THE CITY OF KEY WEST

ADDENDUM NO. THREE ITB 13-024 Fort Street Parking Lot

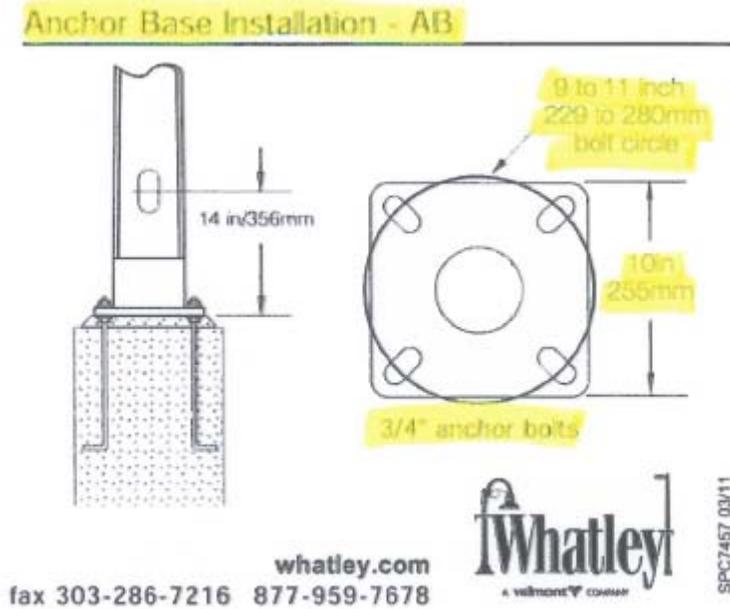
Refer to Lighting Plan, Sheet E-1, Type "A" fixture with Whatley lamp pole is rated at 150 mph. Current code requires 180 mph rating.

Manufacturer states Lamp Post, Model No. XF45-D9M, anchor-base installed, will meet 180 MPH wind speed loading. (Manufacturer to provide wind load data as part of shop drawing submittal.)
